Randwick Local Planning Panel (Electronic) Meeting

Thursday 14 March 2024

Development Application Report No. D18/24

Subject: 49-53 Clovelly Road, Randwick (DA/350/2022)

Figure 11 – Proposed Roof and Elevation Plans

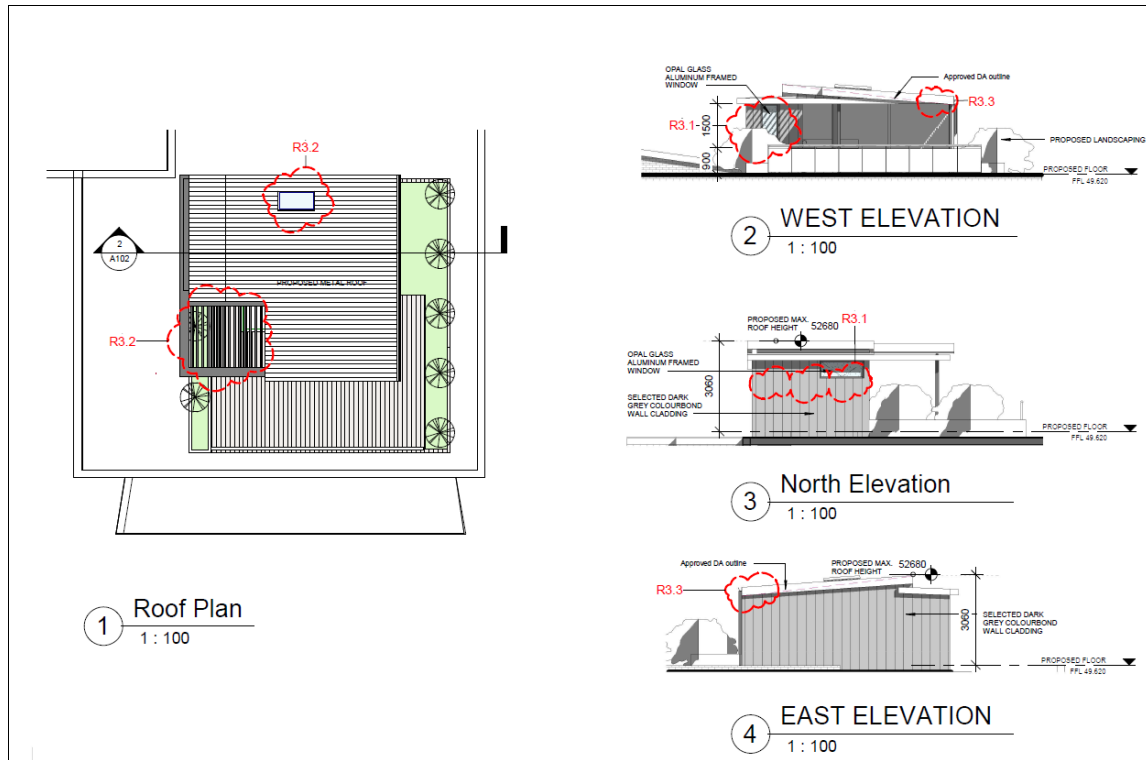
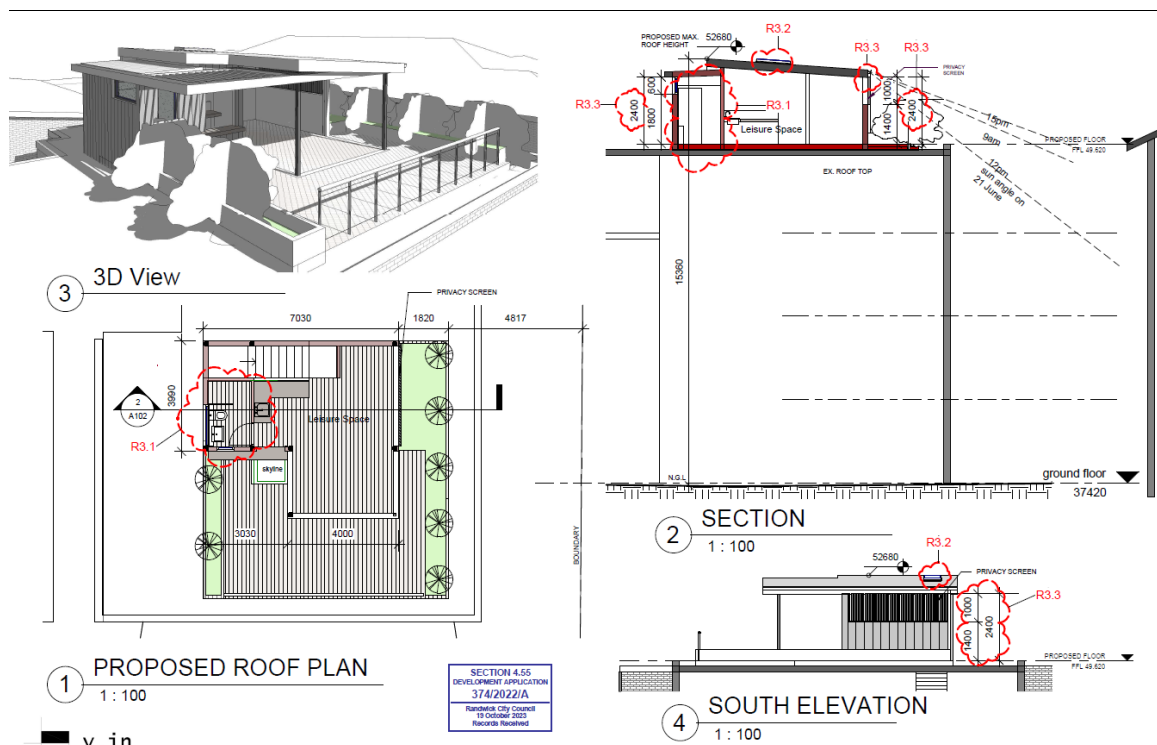
The proposed modification application seeks to amend the approved development by enclosing the northern portion of the terrace to provide a bathroom. The proposed modification will increase the GFA by 3.6m² equating to a total GFA of 2,109.49m² and an FSR of 1.24:1. There will be no change to the approved FSR due to the minor increase in GFA.

However, the approved open terrace structure will become more enclosed under the proposed modification not only because of the proposed bathroom, but also due to the replacement of the approved open screen along the northern elevation with a solid wall and highlight window and the installation of operable louvres above the open northwest corner of the roof. The approved open terrace structure would effectively become enclosed on three sides with only one side remaining open that could be easily enclosed with glazing.

Whilst the subject minor design changes are relatively insignificant when considered in isolation and would not contravene the original reasons for the Panel's support of the proposal in DA/374/2022. Notwithstanding, any future modification application seeking further design changes that result in

the approved open structure becoming a predominantly enclosed structure and that increase the approved FSR beyond 1.24:1, similar to that originally refused by the RLPP would not be supportable.

Figure 13: Ground floor plan, additional decking compared to the existing is highlighted blue and the reduced decking area is highlighted in green.

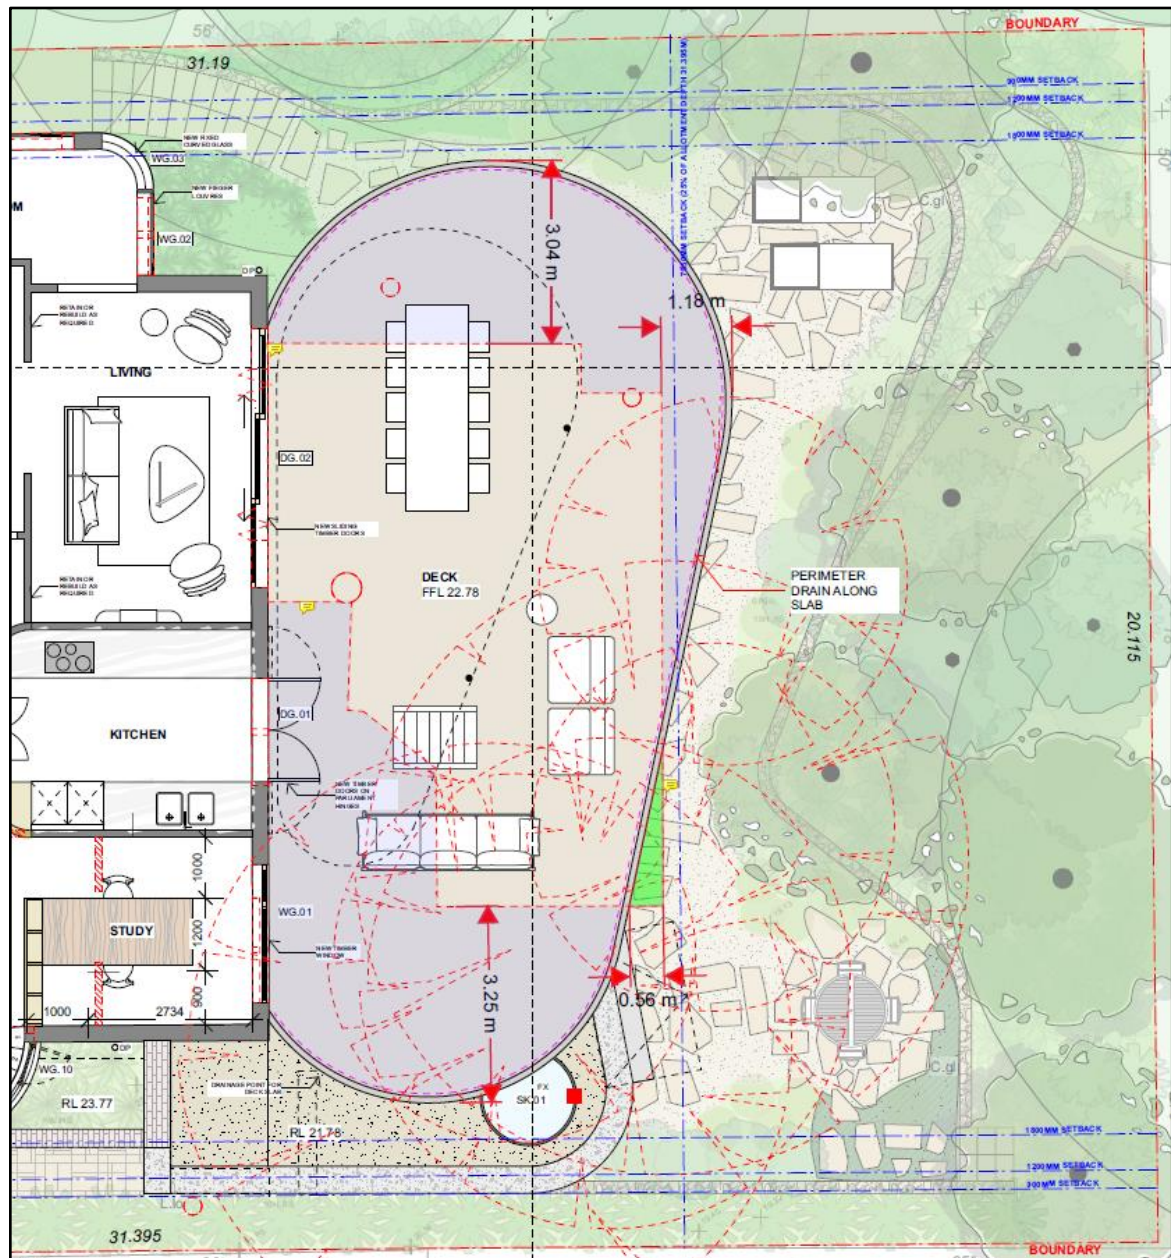
The new decking proposed increases the deck area in the rear setback area from 49.7m² to 95.4m². The angled deck extends approximately 3m north and south compared to the existing deck (highlighted blue below) while reducing a portion of the existing decking on the southeast corner as highlighted green in the ground floor plan below:

The extent of impact from the proposed decking is considered minimal due to the proposed angle of the decking and greater site depth of the south adjoining allotment as previously discussed. Furthermore, terraced floor levels of 3 Wolseley Road as shown in Figure 12 closely reflect the character of dwellings on the east side of Wolseley Road. Given the site depths and the northeasterly/easterly views of the ocean and Wedding Cake Island, the south neighbouring dwellings in Figure 14 are not affected by the proposed additions.

Figure 16: extract of ground floor plan with neighbouring ground floor window highlighted.

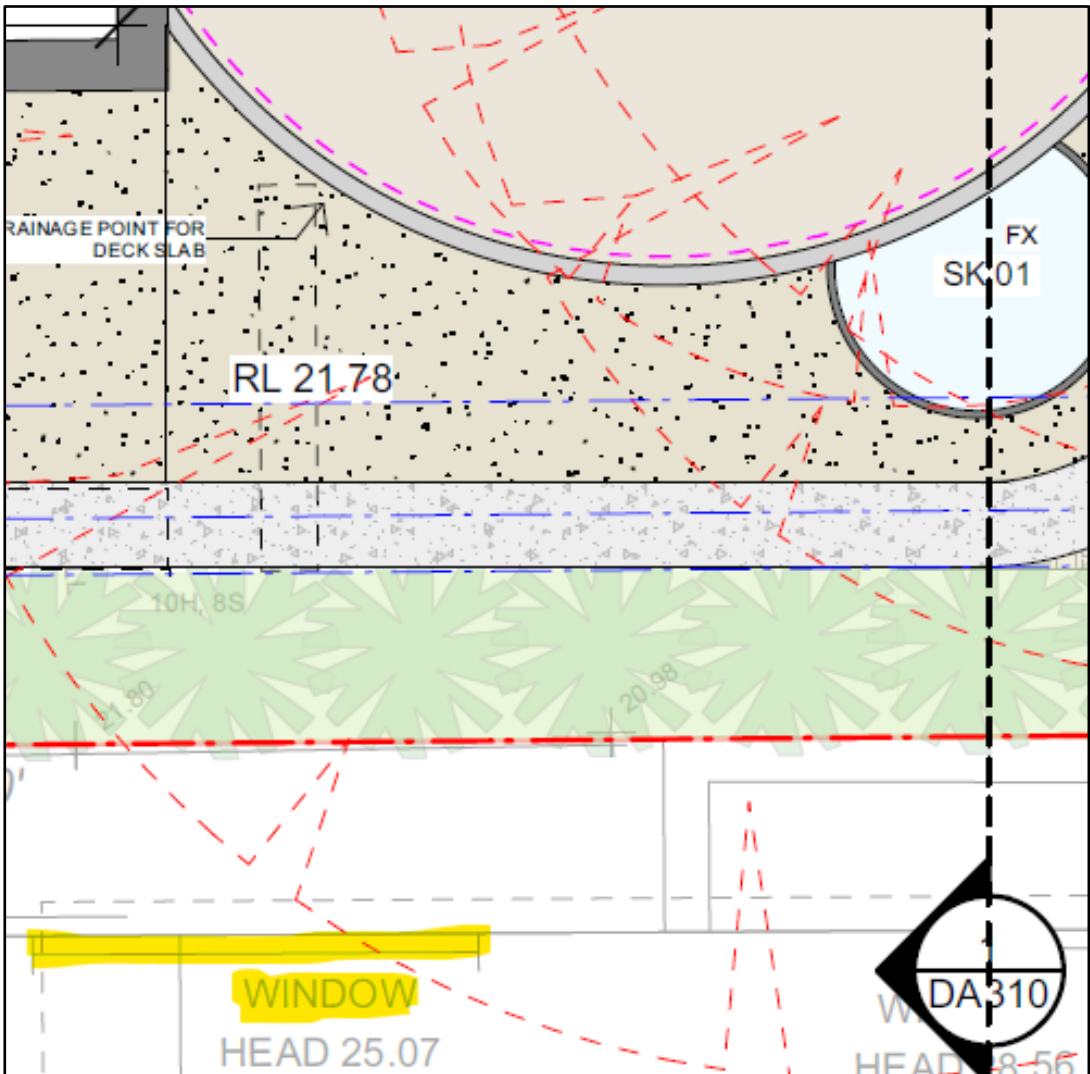
The proposal includes removal of the existing deck and provision of a new deck with access from the kitchen and living room on the ground floor. The site currently does not feature fencing along the south side boundary between the site and No.3 Wolseley Road. The existing and proposed decking therefore currently have a line of sight to the neighbouring north window at the same level as the deck as highlighted on the ground floor plan below.

The proposal does incorporate landscaping along the southern boundary of the site however, landscaping as a main safeguard against overlooking is to be given minor weight as established in the planning principles for Privacy by Roseth SC in *Super Studio v Waverly* [2004] NSWLEC 91 [P6]. Therefore, other measures to prevent overlooking are required. A condition of consent has been recommended to provide a privacy screen on the southern portion of the deck.

In conclusion, the privacy issue raised by potential overlooking is to be resolved through conditions of consent.

Figure 8: Privacy study (Source: Brewer Architects)

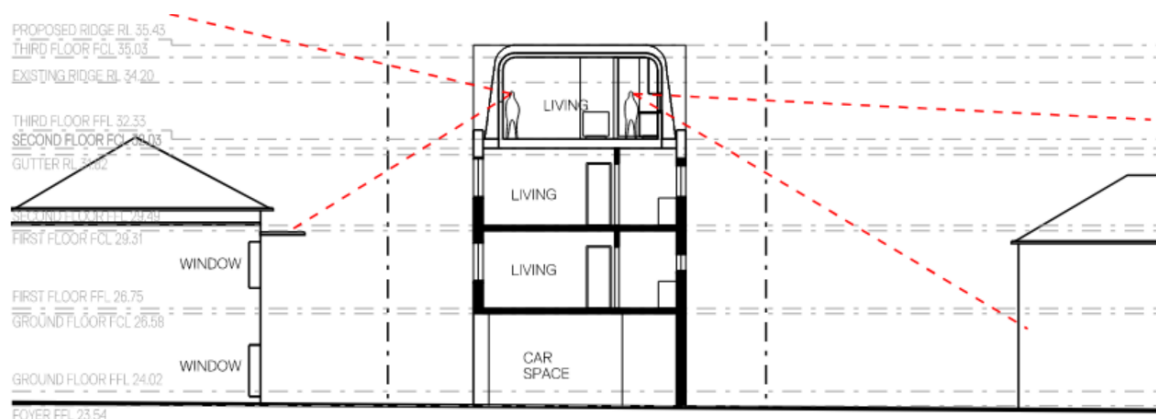
To the west elevation, windows W2, W3, W4, and W5 (to bathroom and ensuite) are provided with sill heights 1.6m above FFL. Overlooking from window W1 (to kitchen) will be limited due to the siting of the kitchen bench in front of the window. As shown in Figure 8, overlooking from this window will primarily be to the roof of the dwelling at No. 31 Melody St. Window W1 has a sill height of RL

33.27, which is 5.41m - 5.44m above the head height of east-facing windows at No. 31 Melody St (ranging from RL 27.83 to RL 27.86).

To the east elevation, windows W7, W8, W9, W10 (to bedrooms) have approximate sill heights of RL 33.53, which is 4.23m - 4.58m above the head height of west-facing windows at No. 3 Abbott St (ranging from RL 28.95 to RL 29.30 at upper level). On this basis, and as shown in Figure 8, the proposed east-facing windows are unlikely to directly overlook windows at No. 3 Abbott St.

Figure 12: Southern drone view from location of rear terrace (Source: Brewer Architects)

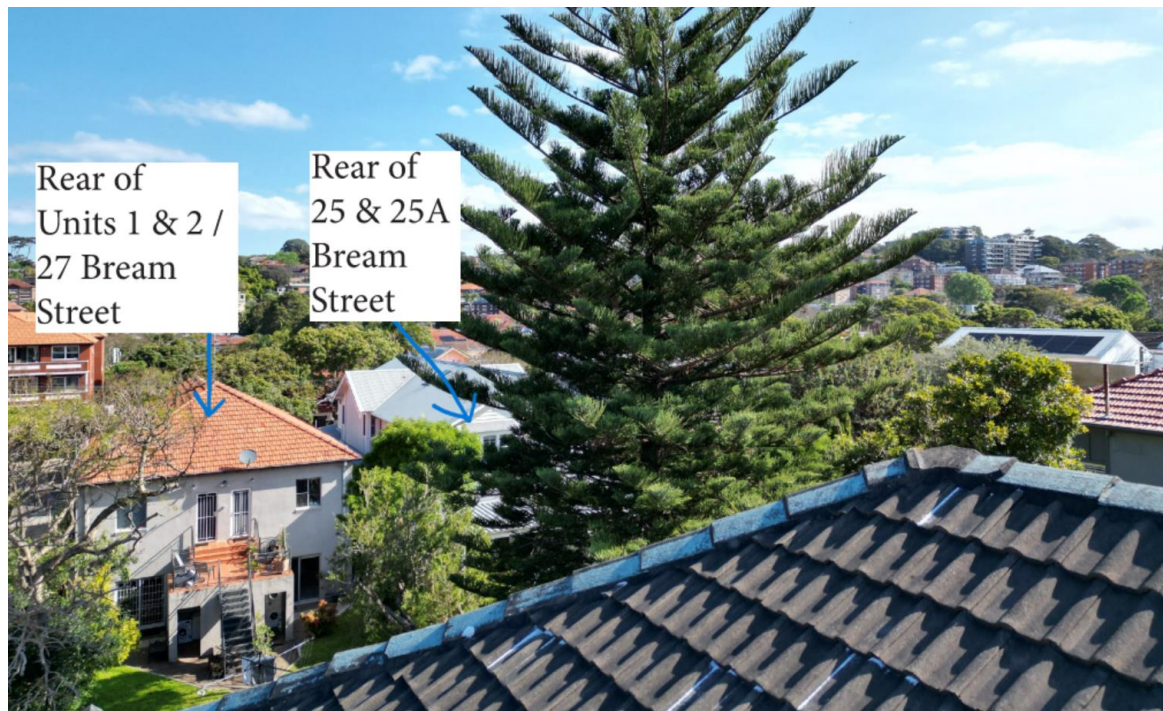
As shown in Figure 12, the southern side of the rear terrace will overlook the upper rear windows of Units 1 and 2 at No. 27 Bream Street. However, based on real estate photographs and floorplans, it is noted that the upper rear windows are to the kitchen of Units 1 and 2 only (not living rooms or bedrooms). Further, the property at No. 25-25A Bream Street is appropriately screened from view by way of an existing pine tree and the inset of the trafficable portion of the addition centrally within the roof form to predominantly obscure downward viewing angles. In this regard, there will be no direct overlooking from the southern side of the proposed rear terrace.

Noting the above, the proposal is considered to achieve reasonable levels of external and internal visual privacy and is therefore consistent with Objective 3F-1 of the ADG.

Figure 22: Floor Layout of 24 Young Street, Randwick (south-adjointing neighbour – Source: www.realestate.com.au August 2021)

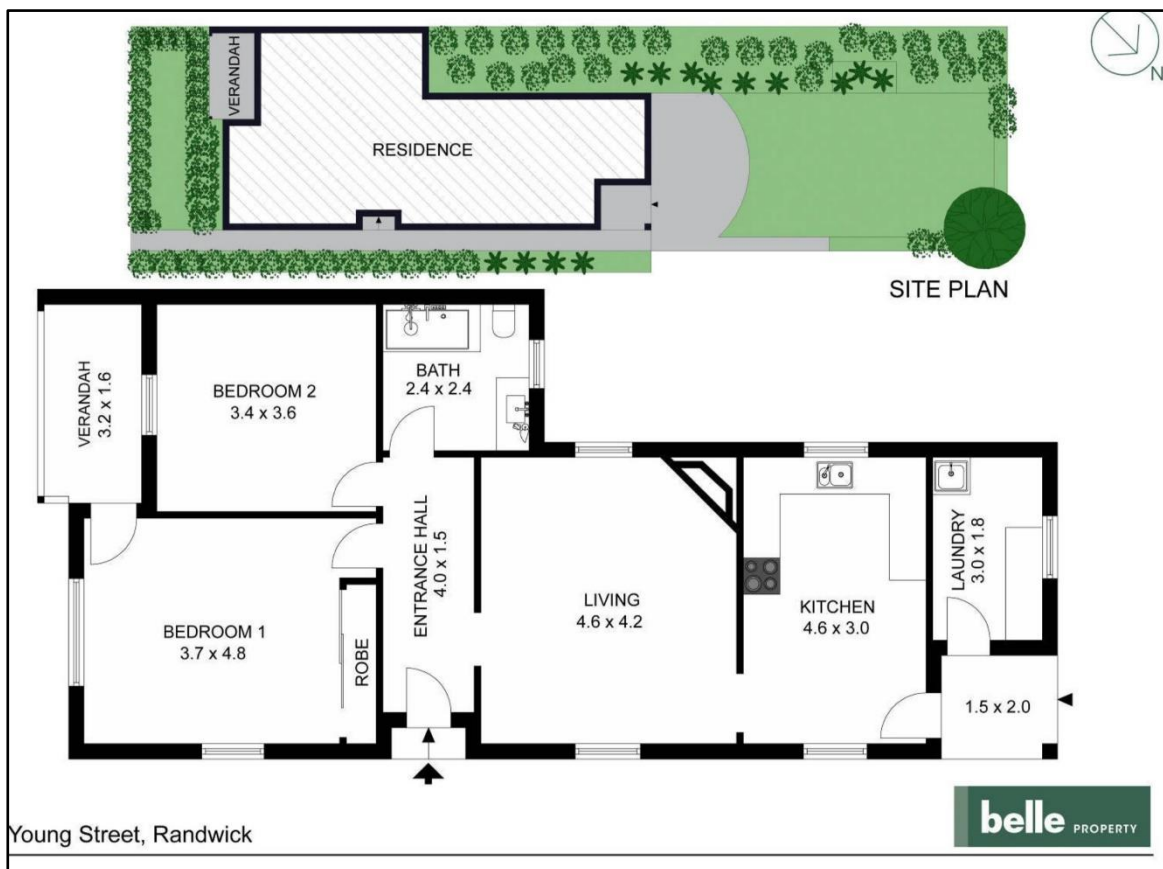
The existing layout of 24 Young Street is shown in Figure 22. It is evident that the north-facing window in the living room is already compromised due to its centralized location. The existing single storey dwelling within the subject site already impacts this window. The proposed development does not increase these impacts. The south-facing window in the living room does not receive direct sun and will not be affected by the proposed development. As such, any impacts and additional shadows cast over living room windows are considered reasonable and acceptable.
